Following a public meeting of the Lindfield Rural Parish Council (LRPC) Planning committee held on the 8th April 2024 – LRPC submit the following comments to planning application DM/24/0446: Land of Scamps Hill, Scaynes Hill Road, Lindfield.

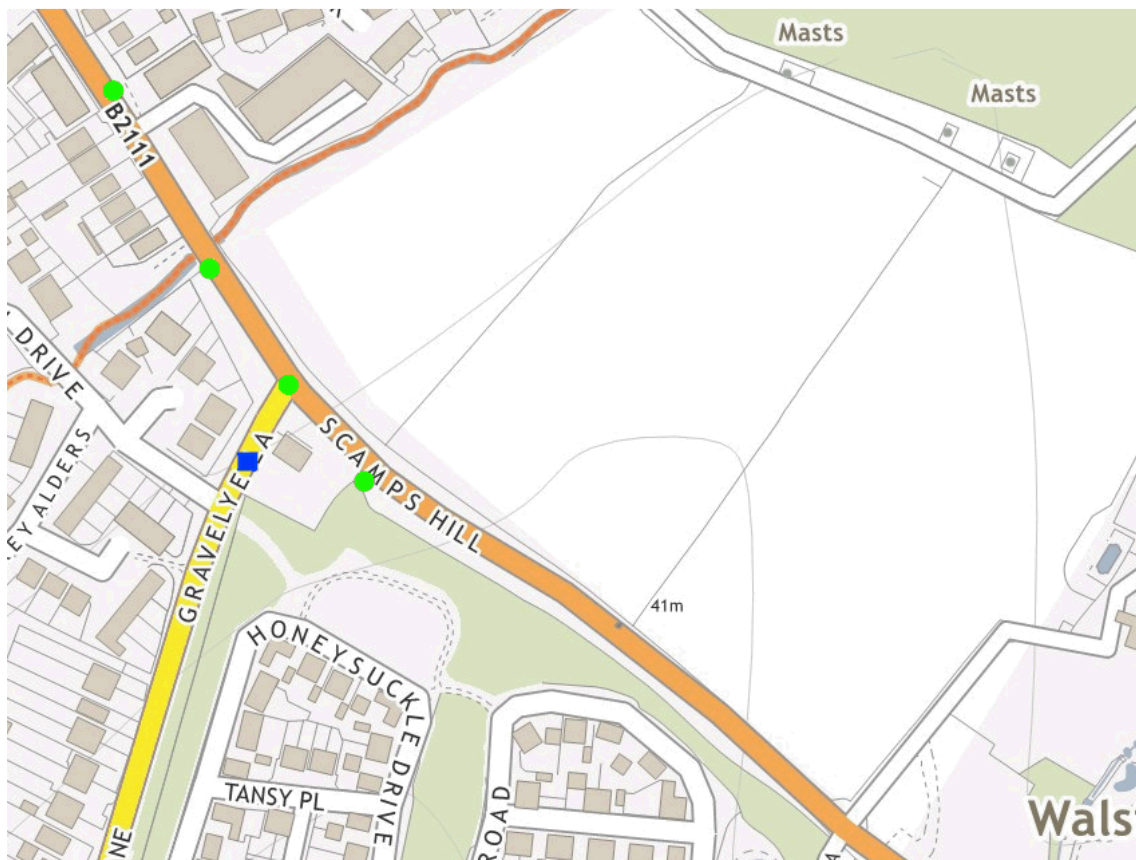
Section 3.6 relates to the collision history. There two incorrect statements in this section. At junction SJ2 the junctions of the A272/B there are 8 recorded RTC's. Contrary to the statement in the TA this does indicate a RTC issue and our understanding is the WSCC have identified this as a junction for treatment. They

also state “there no accidents recorded along the Site frontage. This is also technically incorrect as at least three slight injury RTC’s are recorded on the WSCC database across the site frontage on Lewes Road/Scamps Hill.

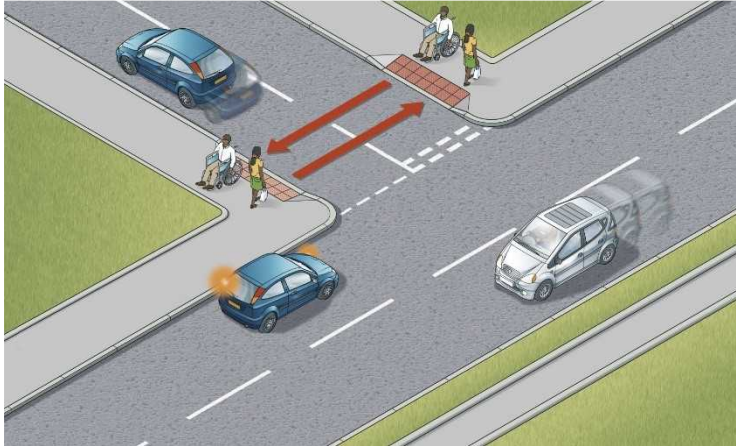
Section 4.1 sets out general design principles leading to a series of proposals. Section 4.1.3 sets out the vehicle access proposal of a priority junction within the 40-mph section of carriageway. No explanation is provided for why this type of junction or location is chosen. There is no design rationale for this decision.

Any new junction in and of itself creates additional safety risks and potential for crashes. A junction within a higher speed limit road has a greater risk of crash severity.

A new junction for a development in this location would be better located within the current 30 mph or integrated within an existing junction. This is not considered or discussed.

The chosen junction type follows DMRB guidance which is for high-speed roads. This is inappropriate for this location. The layout as provided would cause safety issues for pedestrians as it encourages high speed exit/entry which supports drivers failing to comply with Highway Code rule H2 – repeated below:

- an alternative junction layout is provided within the current 30 mph area ideally at the Graveley Road/Scamps Hill junction, and the arrangement includes dedicated controlled crossing provision for pedestrians across both Lewes Road and Graveley Lane.
- Footways to/from the development and bus stops are upgraded to Inclusive Mobility guidance standards where practical and this includes the stops in Walsted.
- Bus stops are upgraded to include shelters and seating, step free accessible access, information and bus stop cages/clearways.
- Broader measures to reduce vehicle traffic generation and support choice for walking and cycling/wheeling.
- The cycle facilities are reviewed to consider integration with SHLAT and broader network provision to support wheeling trips to Lindfield and surrounding schools.
